TECHNICAL MEMORANDUM

To: Ray Cody and Karen Simpson, United States Environmental Protection Agency, Region 1
From: Matt Lundsted and Nick Cristofori, CEI and Bruce Jacobs and Ken Hickey, WaterVision
Subject: **Task 1 Summary Memo: A description of recently completed data collection, conceptual design, and associated tasks.**
Date: February 17, 2015

This attachment contains comments received from EPA staff following the meeting of January 13, 2015 on the conceptual design of the proposed BMP projects. Design Team responses follow each comment in italicized text.

Sheet
Figure
2

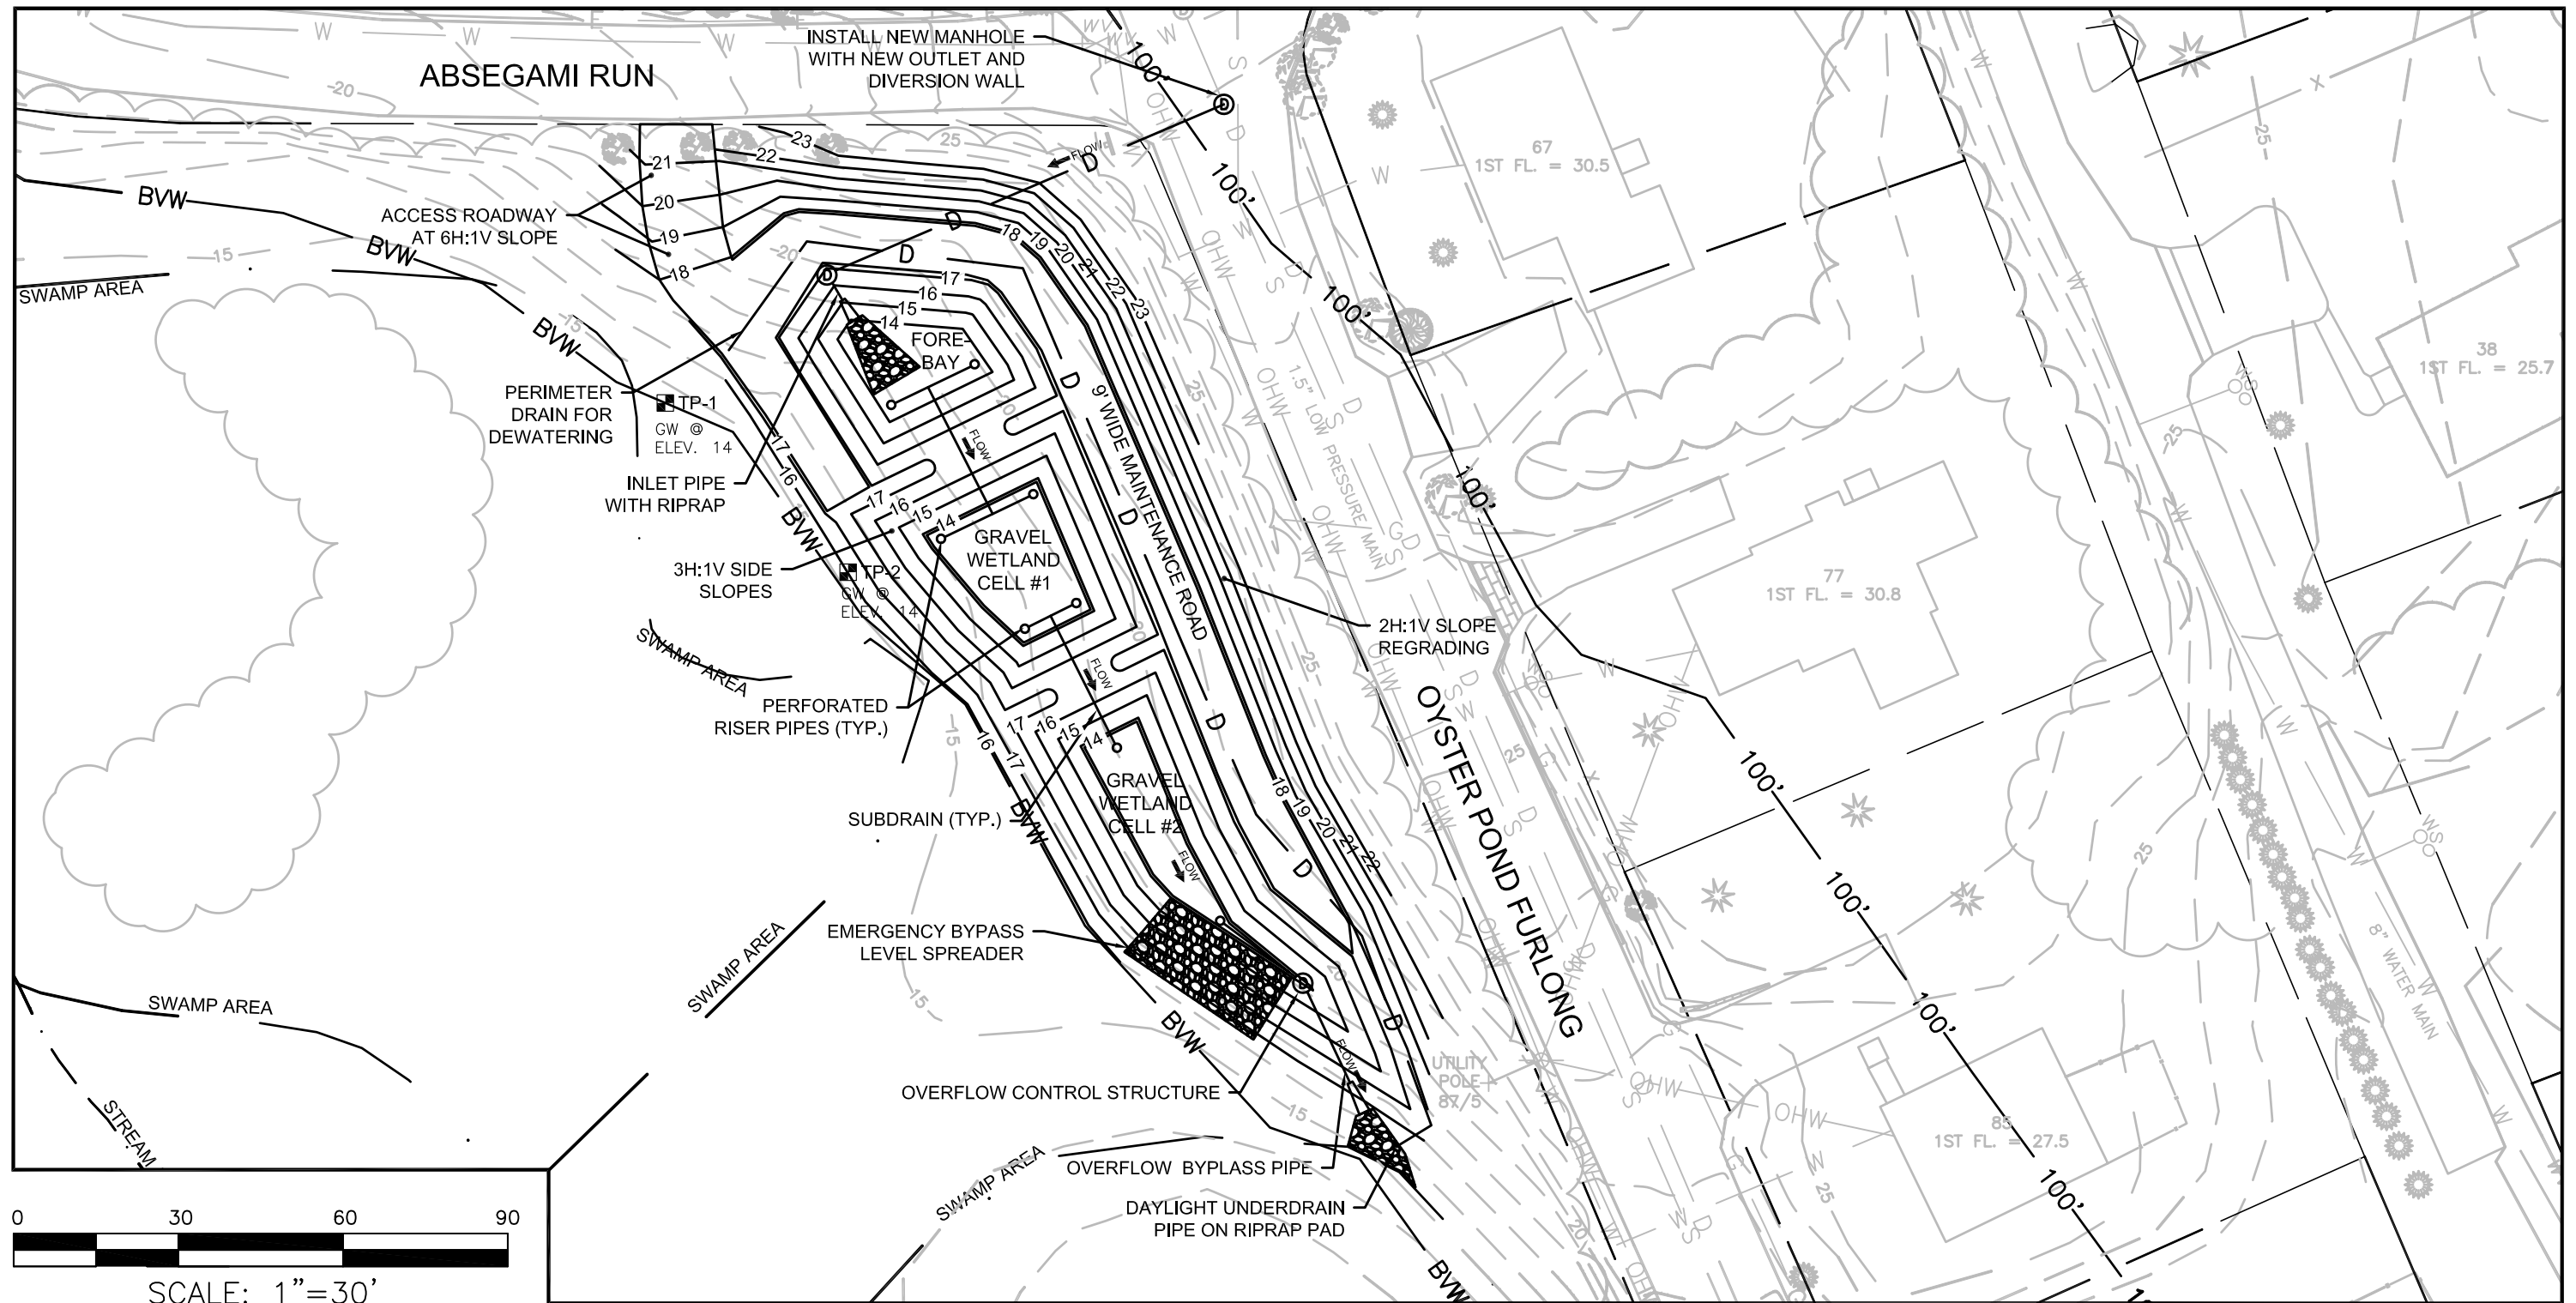
1. I read the document and reviewed the plans. I agree that according to the plan Figure 2 for Oyster Pond BMP in Chatham that a Corps permit would not be required according to these plans which depict no action [sic] physical filling in wetlands. The emergency bypass level spreader and overflow bypass pipe riprap is depicted adjacent to the wetland line. The plans do not indicate a datum which must be included and typically is required in NAVD 88 datum. [Edward Reiner]

4. Lastly, insofar as the overflow bypass pipe on the site plan (and the bottom of page 3 of the write up) which appears to discharge into the wetland area, would it not be advisable or preferred best engineering practice to avoid discharging into the wetland system? If additional funding could be obtained, is there a way to move this pipe and/or tie back into the MS4 system? It might at least be helpful to consider other options and cost them out. [Lynne Hamjian]

Acknowledged. Revised design plans and final Task 1 Summary Memo (T1SM) now indicate a horizontal datum of NAD83 and a vertical datum of NAVD88, consistent with survey information and MassGIS LiDAR used for design purposes.

The commenter is correct that the overflow bypass pipe should ideally not discharge directly into the wetland area in order to preserve existing hydrologic characteristics. The bulk of wetland areas are located directly west of the proposed BMP. As the wetland complex moves further south, it becomes channelized into a drainage ditch which drains through a culvert below two driveways associated with house numbers 98 and 100 on Oyster Pond Furlong. At this point, it no longer functions as a wetland, but instead as a drainage conveyance channel. This channel ultimately flows back into the drainage trunk line below Oyster Pond Furlong south of the southernmost driveway where it outlets into Oyster Pond approximately 500-feet further. Pending final design, it appears likely that the overflow pipe and erosion pad will be rotated such that it faces nearly due south, and thus discharges directly into the drainage channel portion rather than wetland areas. The final T1SM has been updated to clarify these connections.

Should additional funding be available, it appears feasible to tie back into the existing drainage system. This option would either include installation of an additional new manhole in Oyster Pond Furlong and trenching an additional 75 linear feet of pipe, or tying into an existing manhole and trenching an additional 140 linear feet of pipe. Costs for either option are estimated to be approximately \$30,000. A new section in the final Cost Memo titled Optional Items has been added to address this item.

**Figure
4**

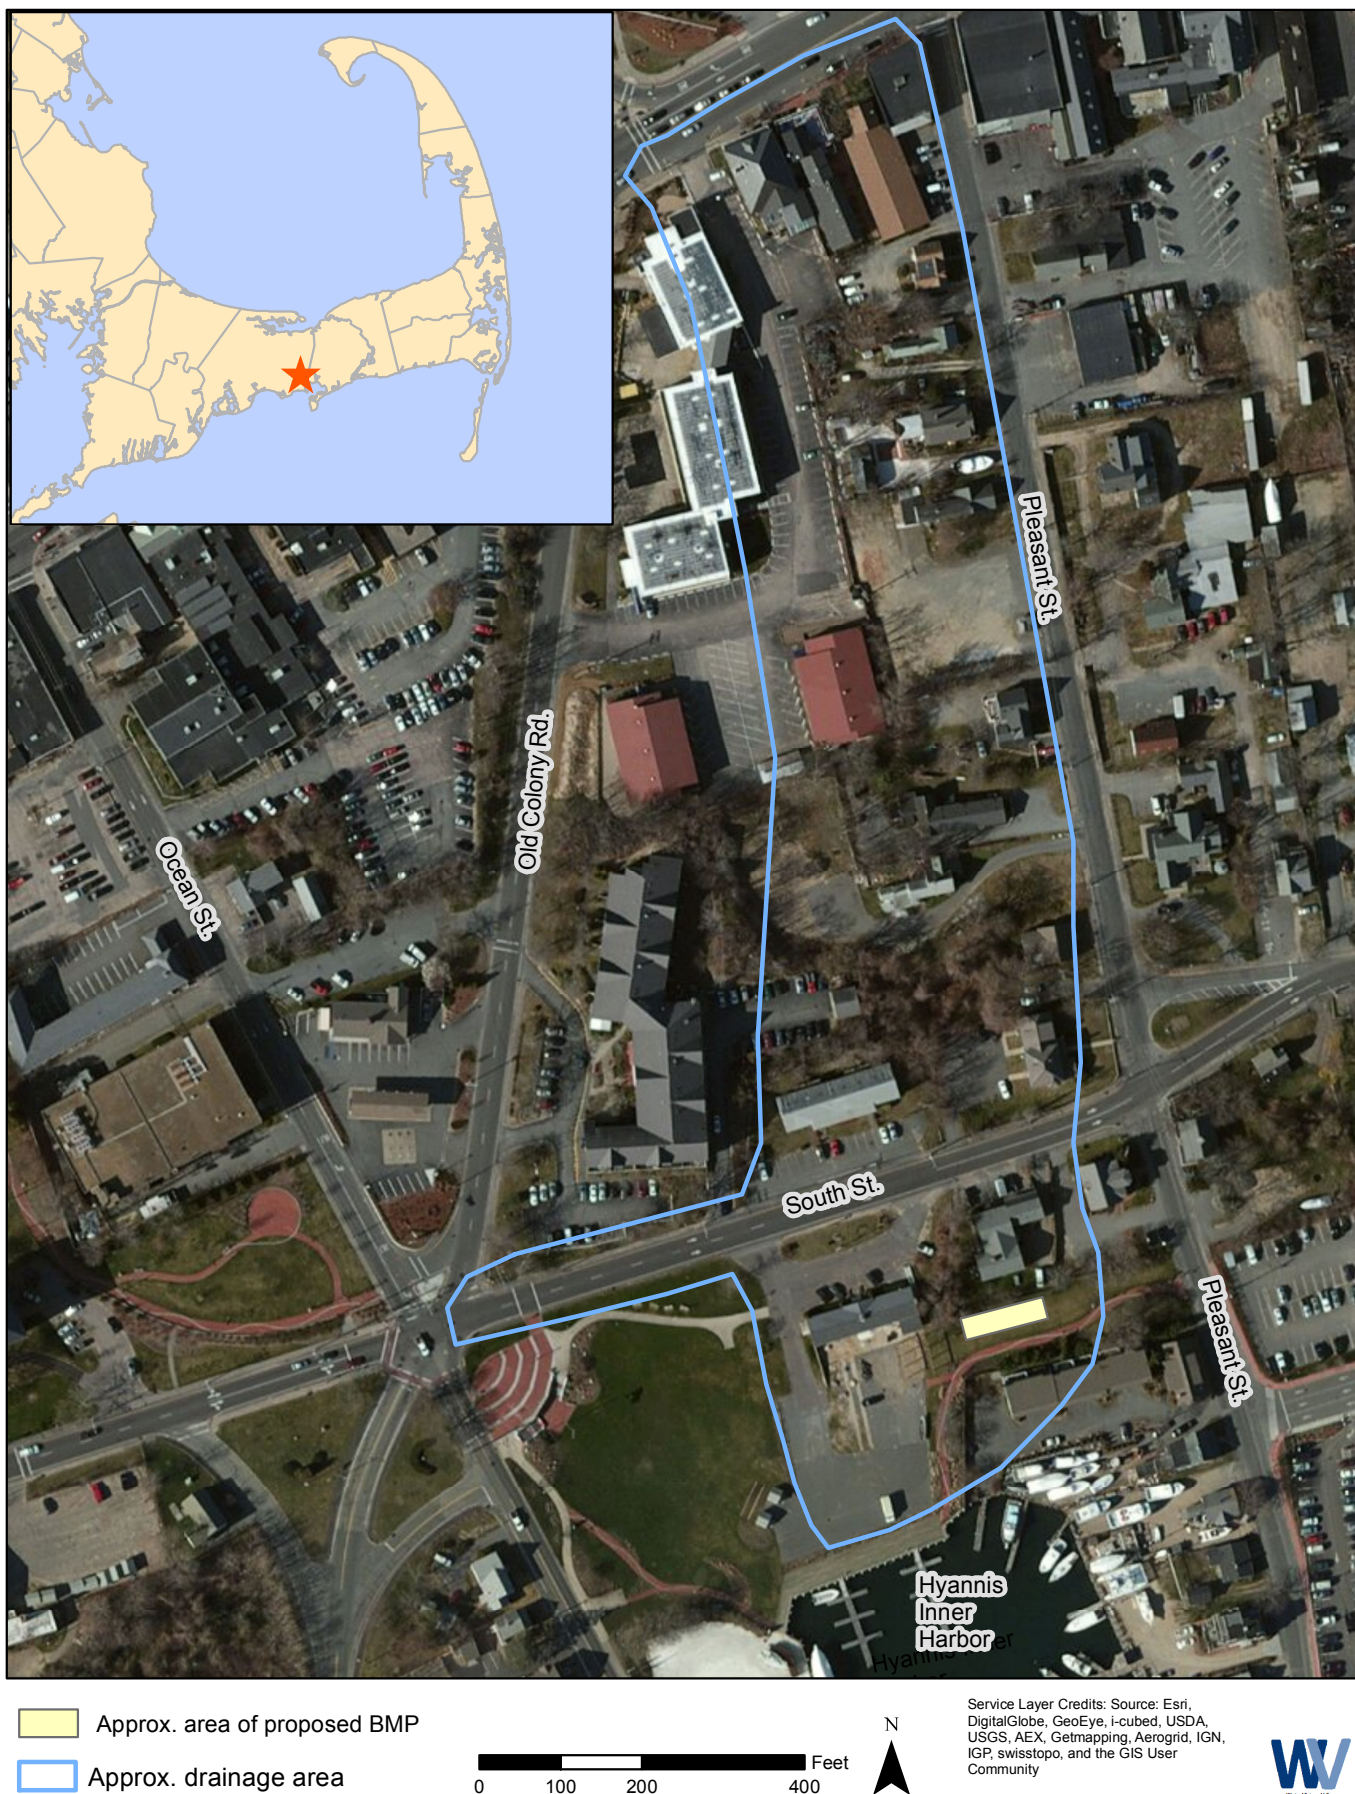
33. Design Figures. As we discussed, it would help to clarify / label the aerobic versus anaerobic zones of the treatment cells; otherwise, as we discussed, it almost appears as if the entire first of the two cells is an aerobic treatment cell and that the system only treats

Acknowledged. Revised design plans are attached to this response to clarify aerobic and anaerobic portions of each cell. Additionally, Figure 4 and Figure 7 contain cross sections for each BMP and outline a step-by-step guide to the stormwater treatment process and identifies all major design features.

BARNSTABLE, PROPOSED CONCEPTUAL DESIGN
INTERSECTION OF SOUTH STREET AND PLEASANT STREET

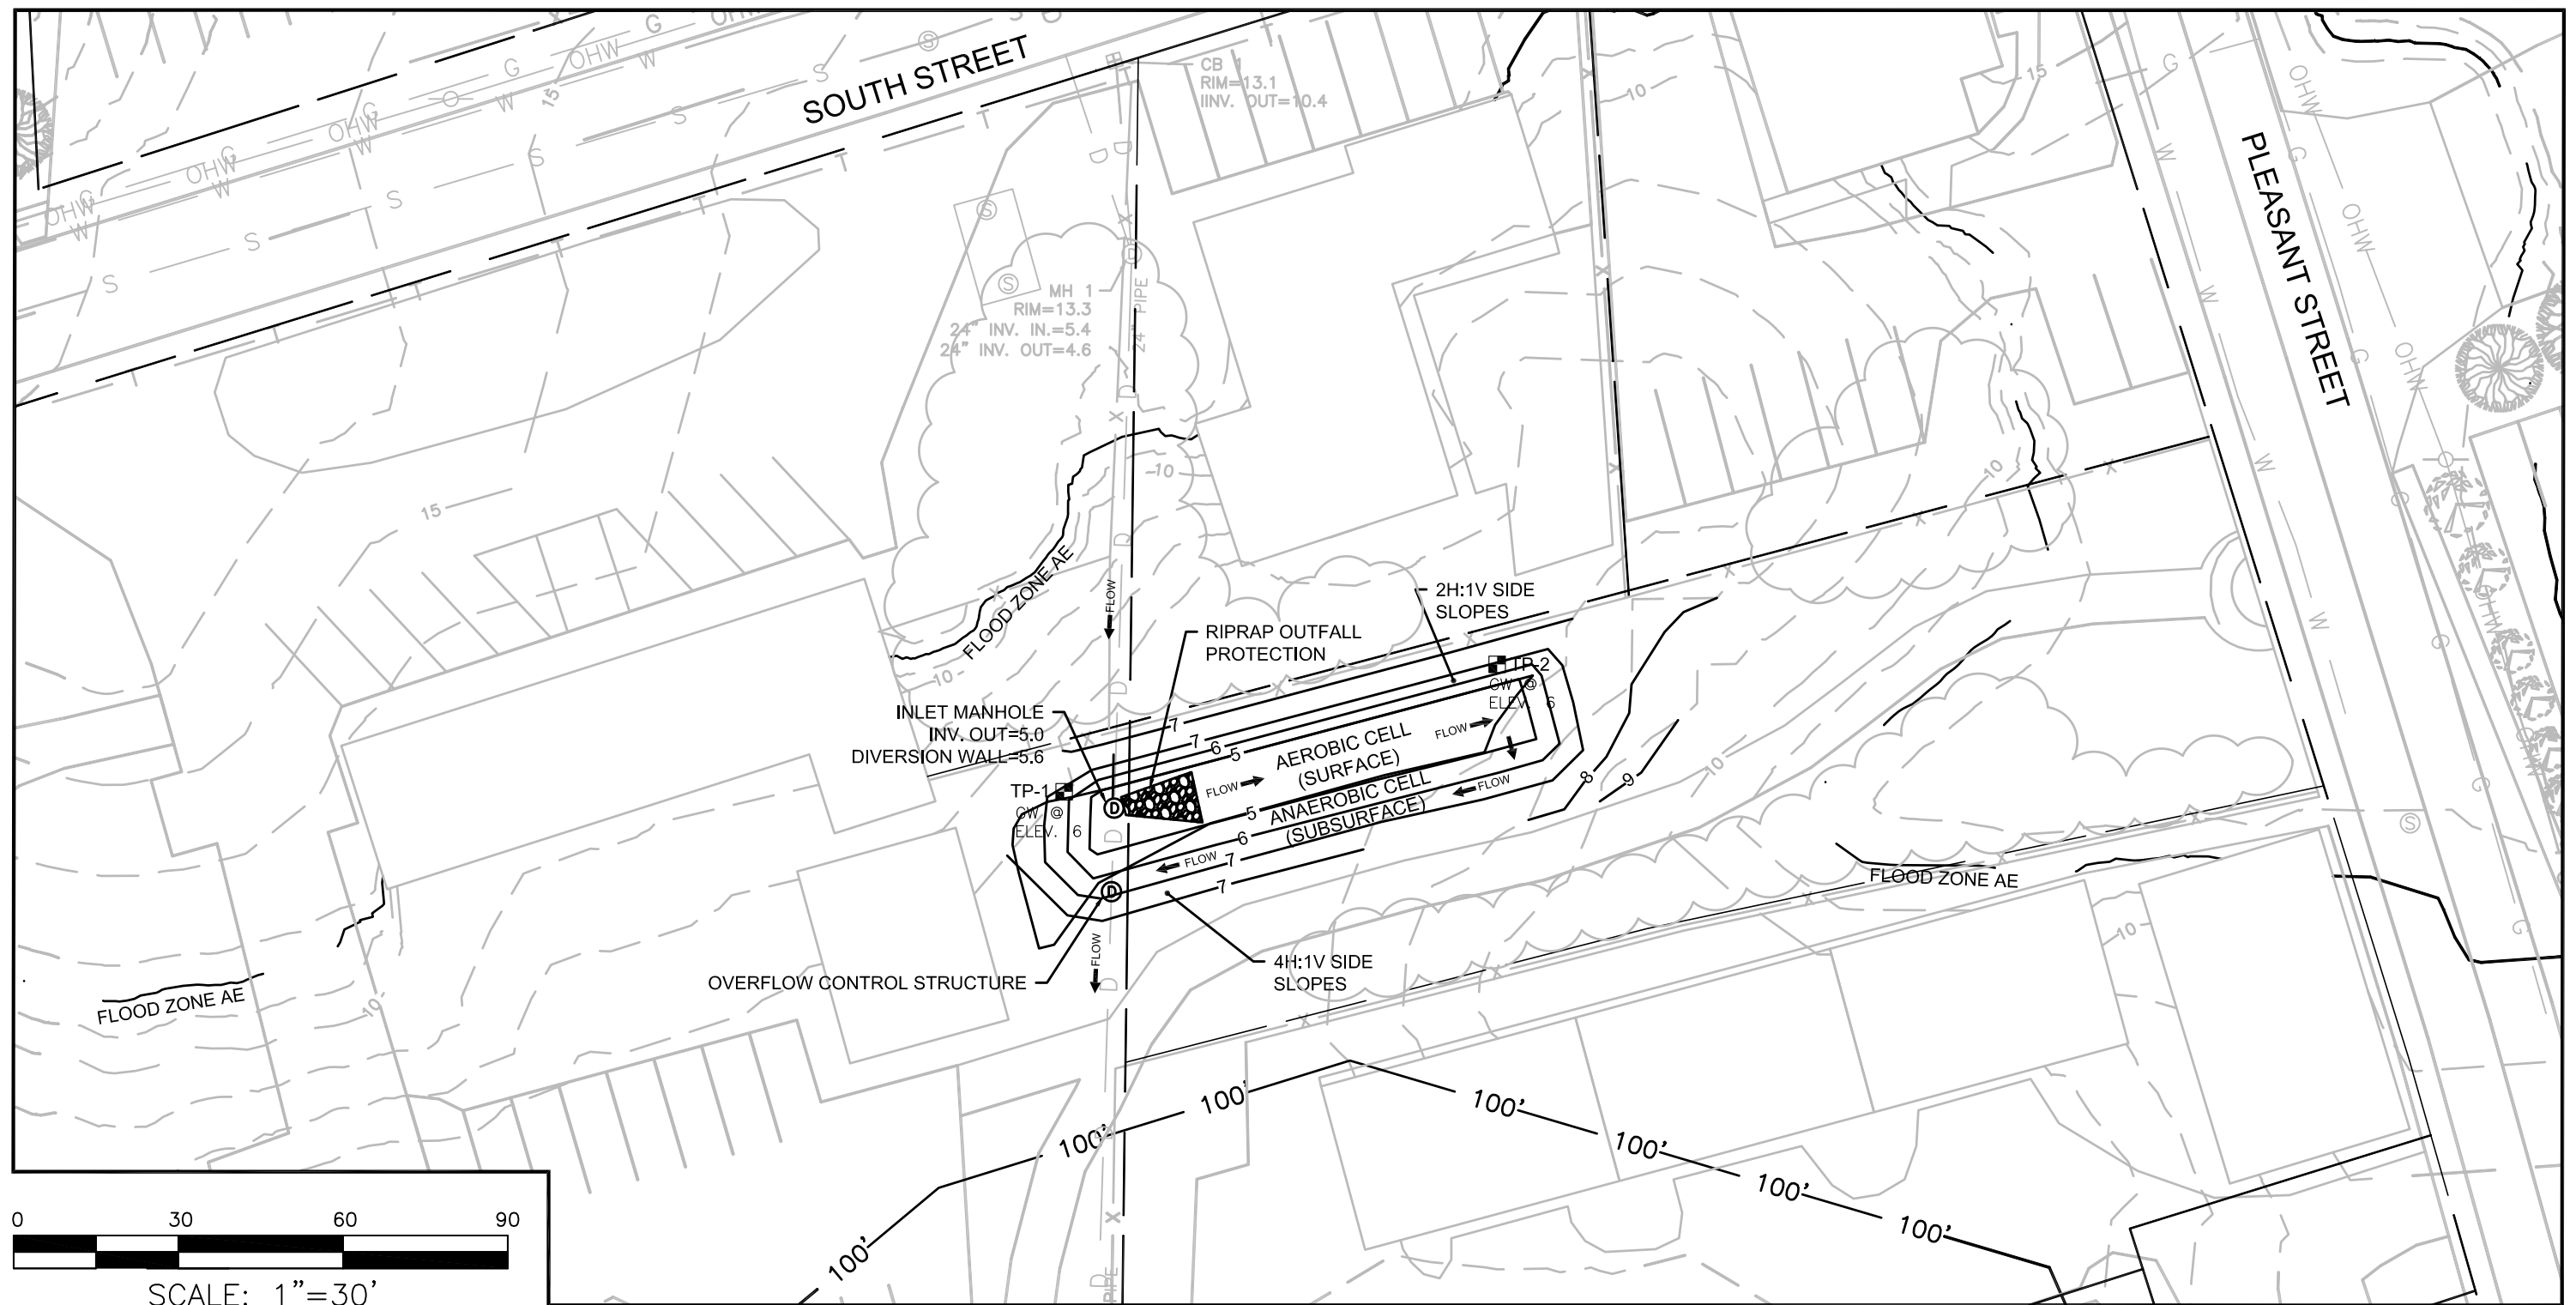
2. The plans for the Hyannis site depict and claim that no permitting will be needed since the location is not in wetlands and out of the buffer zone. I noticed, however, that the site itself may be in the 100-year flood plain and the aerobic cell (surface) will be excavated below 5 feet elevation (no datum reference provided). The plans should provide the datum reference (NAVD 88) and information on the 100-year floodplain. The potential impacts of sea level rise should also be considered as it relates to any backwater from the culvert drain at Hyannis Harbor. [Edward Reiner]

The Barnstable location is situated within a Flood Insurance Rate Map (FIRM) Special Flood Hazard Area (SFHA) area, classified as Zone AE with a Base Flood Elevation (BFE) of elevation 12.0 (NAVD88) based on FIRM Panel 0569J for Barnstable County. This zone is classified as areas subject to inundation by the 1-percent-annual-chance flood event, also known as the 100-year storm flood zone. Design plans have been updated to reflect this area.
